ACCESS REPORT

PROJECT APPLICATION

RACECOURSE PL, EVANS AVE & BARBER AVE EASTLAKES TOWN CENTRE

MIXED RESIDENTIAL / RETAIL DEVELOPMENT

External Pathway Links and Building Entrances (Parts D3.2 & D3.3 of the BCA)

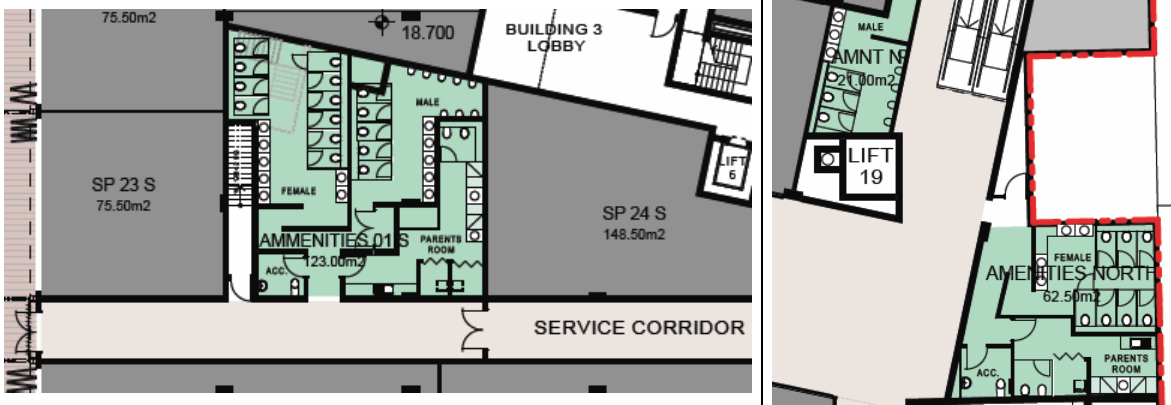
BCA / DDA Compliance	Complies
<p>I. Street Frontage Retail & Common Domain Entrances – The development proposes multiple pedestrian site entrances to the site including the following:</p> <ul style="list-style-type: none"> (a) North side of the development provides a central 1:20 gradient walkway from Evans Avenue @RL18.380 to the Mall North @RL18.700 which facilitates access to the retail areas and lift 17 to access the residential Building 1 and Lift 19 to the residential Building 1A. (b) Evans Avenue also provides direct on-grade generally level entry to residential lift lobbies 19 and 22 to access Buildings 1A and 1B on the northern side. (c) South side of the development provides a central 1:20 gradient walkway from Evans Avenue @RL18.560 to the Mall South @RL18.700 which facilitates access to the retail areas and lift 17 to access the residential Building 1 and Lift 19 to the residential Building 1A. (d) Evans Avenue access to the Serviced Apartment lift lobby at RL18.700 is also a generally level on-grade accessible entry. (e) Retail Speciality Shops 15-20 propose levels of 18.130 to 18.600 to reflect the slope of Evans Street and achieve level threshold entries. (f) Evans Avenue accessways to the Buildings 2 and 3 lift lobbies at RL18.700 proposes a 1:14 ramped accessible entry, although detailing of the position of the ramps shall be amended at a future design stage to be recessed 900mm from the boundary to accommodated handrails and tactile ground surface indicators as required by AS1428.1. The stairway at the boundary shall also be recessed 900mm for the same reasons to comply with AS1428.1 and satisfy Parts D3.2 and D3.3 of the BCA. (g) The western podium terrace adjoining the public park (Eastlakes Reserve) facilitates accessible entries to Building 7 lift lobbies and Retail Speciality Shops 14, 22, 23, 27, 31, 32, 01-05, 10, 11, 12, 13 with level threshold entries and access to the indoor South Mall areas. (h) Barber Avenue (south) proposes a 1:14 ramped accessible entry to the South Mall to ensure equitable access from all approaches to the development. (i) Barber Avenue (east) proposes a 1:14 ramped accessible entry to the western terrace to ensure equitable access from all approaches to the development, although detailing of the position of the ramp shall be amended at a future design stage to be recessed 900mm from the boundary to accommodated handrails and tactile ground surface indicators as required by AS1428.1. (j) Barber Avenue also provides direct on-grade generally level entry to residential lift lobbies to access Buildings 5(1) and 5(2) on the eastern side. (k) Retail Speciality Shops 08, 26, 21 propose levels of 18.100 to 18.500 to reflect the slope of Barber Street and achieve generally level threshold 	<p>YES</p> <p>YES</p> <p>YES</p> <p>YES</p> <p>YES at CC stage</p> <p>YES</p> <p>YES</p> <p>YES</p> <p>YES</p> <p>YES</p>

BCA / DDA Compliance	Complies
<p>entries.</p> <p>2. The plans shall confirm the ramps and stairways shall be setback from the property boundary by at least 900mm to accommodate tactile indicators and handrails in accordance with ASI428.1 and satisfy Part D3.3 of the BCA.</p> <p>3. With respect to the actual entrances into the street frontage retail tenancies there will be generally level access with several providing 1:8 threshold ramps, which will be detailed to be 35mm maximum rise and 280mm maximum length in accordance with ASI428.1 to comply and satisfy D3.2 of the BCA.</p> <p>4. Residential Entry Lobbies – The abovementioned accessways also facilitate appropriate access from the property boundary the entry lobbies consistent with ASI428.1 to satisfy D3.2 and Table D3.1 of the BCA.</p>	<p>YES at CC Stage</p> <p>YES at CC stage</p> <p>YES</p>

Accessibility of Common Domain Areas (Table D3.1, Parts D3.2 & D3.3 of the BCA)

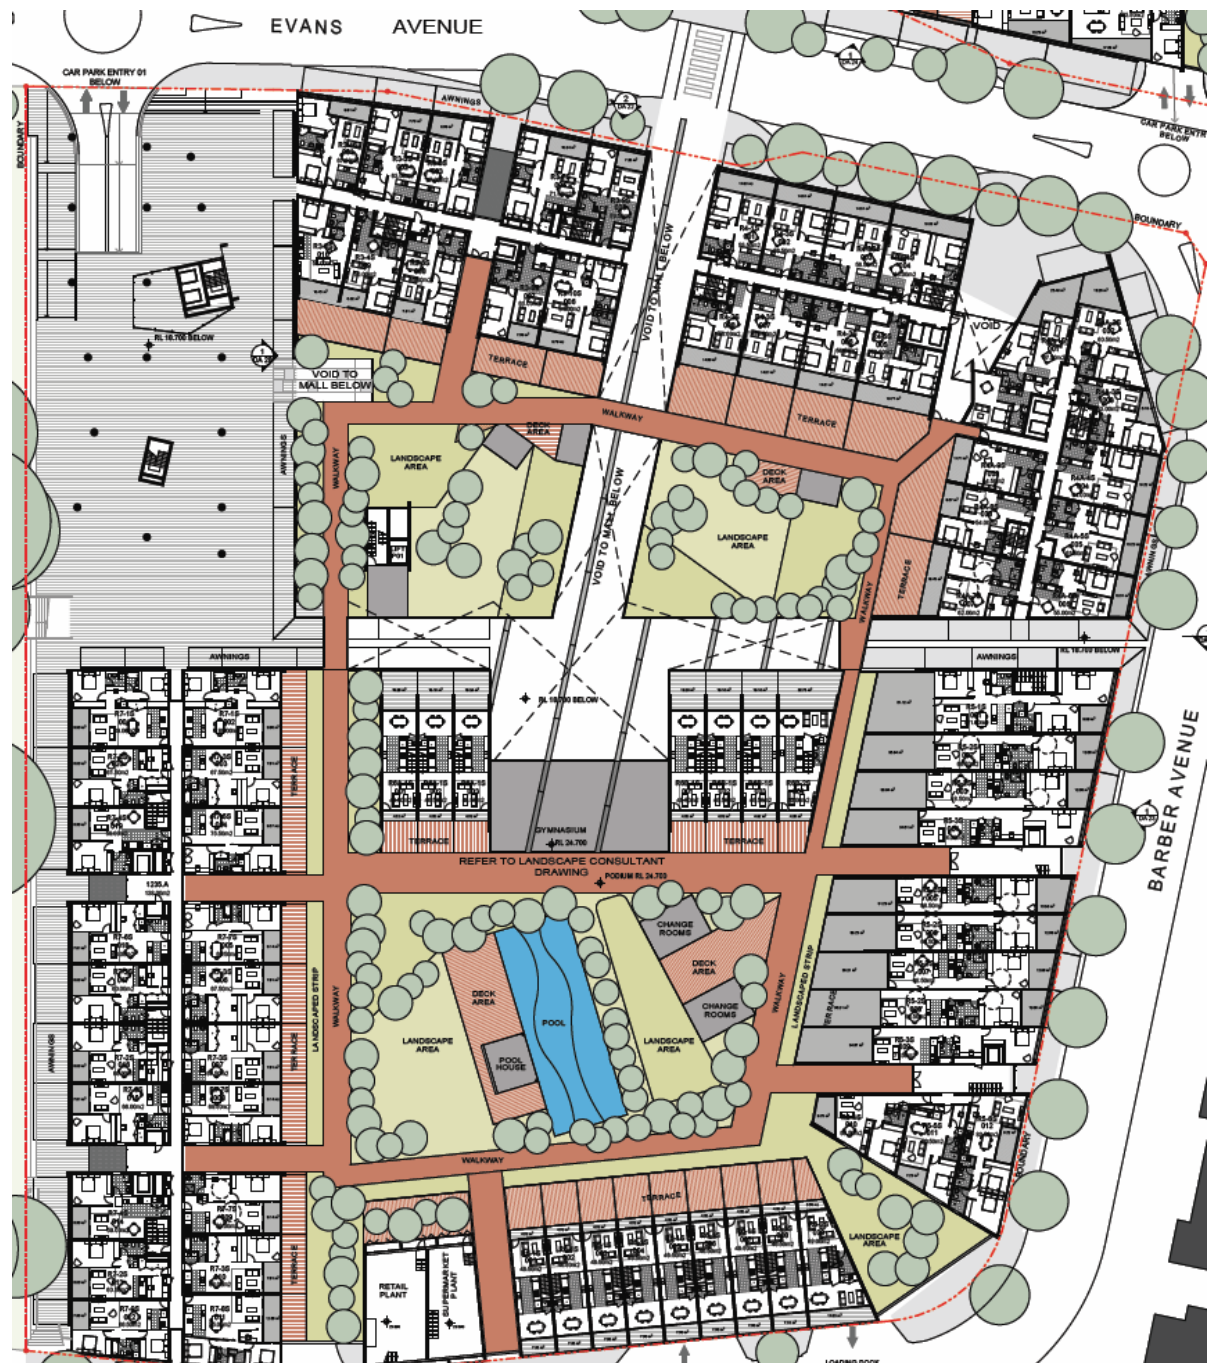
BCA / DDA Compliance	Complies
<p>13. In accordance with Table D3.1 of the BCA a development is required for Class 2 Areas of a development (residential flat buildings);</p> <ul style="list-style-type: none"> To provide a pedestrian entrance to be accessible to at least one (1) floor containing sole occupancy units and to the entrance doorway of each sole occupancy unit located on that level, and To and within not less than one (1) of each type of room or space for use in common by the residents, including a cooking facility, sauna, gymnasium, swimming pool, common laundry, games room, individual shop, eating area, or the like. Where a ramp complying with AS 1428.1 or a passenger lift is installed — <ul style="list-style-type: none"> a) to the entrance doorway of each sole-occupancy unit; and b) to and within rooms or spaces for use in common by the residents, located on the levels served by the lift or ramp.

Southern Residential Buildings 2 and 7

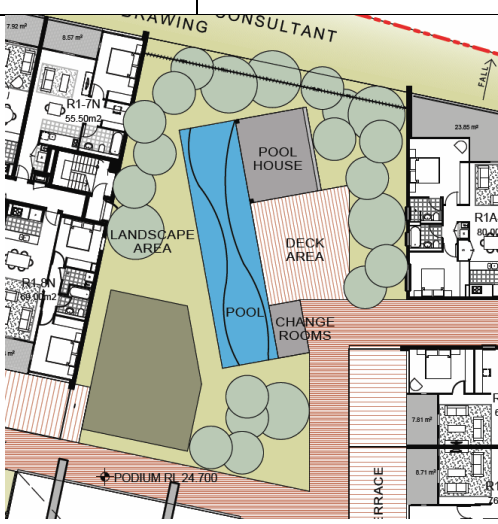
20. **Southern Residential Buildings 2 and 7** - The ground level proposes 1:14 ramp access from Evans Avenue and Barber Avenue to the raised podium terrace on the western side of the site which facilitates level access to the entry lobbies for Buildings 2 and 7 which incorporate lifts to access upper levels to ensure equitable access to all unit entrance doorways in accordance with AS1428.1 to satisfy Parts D3.2/D3.3 of the BCA and Council's DCP 35.

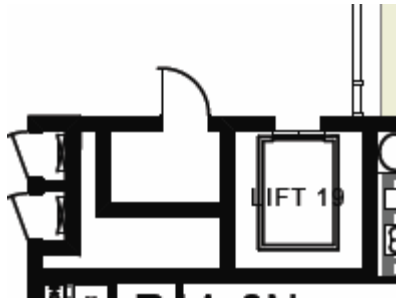
21. The construction documentation shall ensure that entry doorways shall incorporate level landings and threshold ramps (max 1:8 X 35mm X 280mm) while details of door schedule and door hardware shall confirm 850mm clear opening widths with lever and D-pull handles and other features to comply with

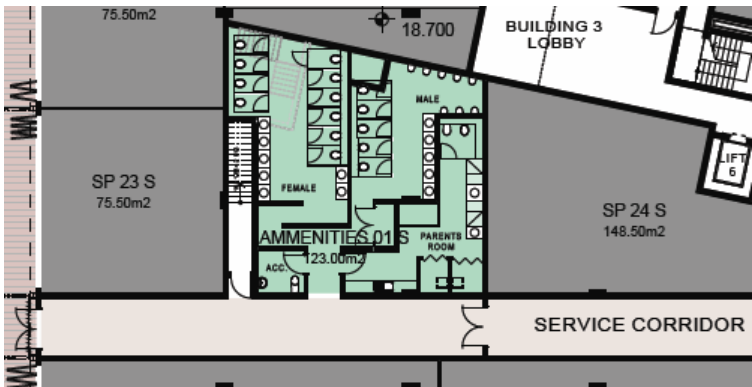
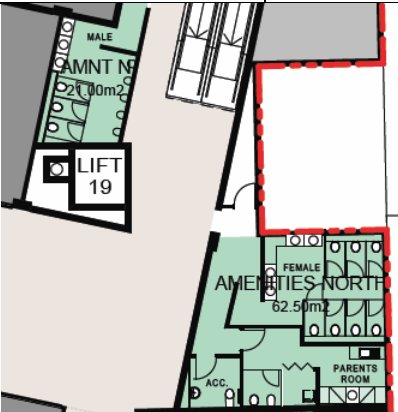
BCA / DDA Compliance	Complies
	Complies
<p>35. Lifts -The plans indicate the Residential lift cars will be at least 2000mm X 1400mm to satisfy the E3.6 of the BCA and will be detailed to comply with AS1735.12 – <i>Lifts For People With Disabilities</i>.</p>	YES
<p>36. Common Corridor Access to Apartment Entrance Doorways – On the upper levels 1 to 7 the plans show 1800mm-3200mm width lift landings which provide direct access to 1400mm minimum width common corridor accessways to access all apartment entrance doorways in Buildings 1, 1A, 2, 3, 4, 5, 7.</p> <p>37. The 1400mm minimum width common corridor accessways and 1600mm X 2100mm end corridor spaces shall facilitate appropriate doorway access and Turning Areas to comply with AS1428.1 and Part D3.3 of the BCA.</p> <p>38. The combination of the lift landings and common corridors provide the configurations and spatial areas to facilitate Passing Areas in accordance with AS1428.1 and Part D3.3 of the BCA.</p>	YES YES YES

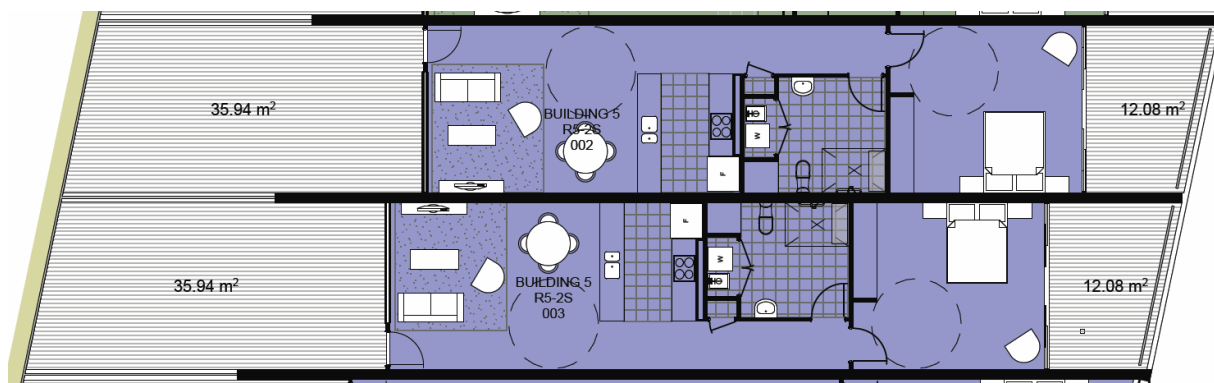
The plans indicate 13 adaptable apartments in three types as shown below;

Building 1 – 3 X 1 bedroom apartments on levels 1, 2, 3

Building 7 – 4 X 1 bedroom apartments on levels 1, 2, 3, 4

Possible 14th Adaptable Apartment in Building 7

Building 5 – 6 X 1 bedroom apartments on level 1
